Access Compliance Report Public Rights-of-Way (Pedestrian Signals)

Main Street: BOLSA_AVE Cross Street: VAN_BUREN_ST Location: NW

ADA ID: SGRK210930110615 Signal Type: One Push Button-Non APS Overall Compliance: No Severity Scores: BTN 1: 25 BTN 2: N/A No BTN: N/A

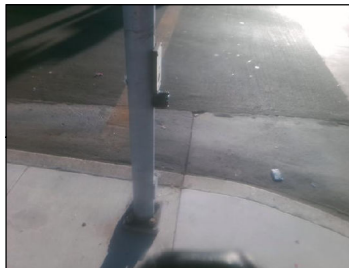
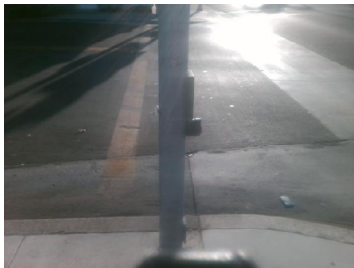
OC Std/PROW: , R404.2

Possible Solutions: Replace Signal Push Button With APS Button. Remove & Relocate Sign.
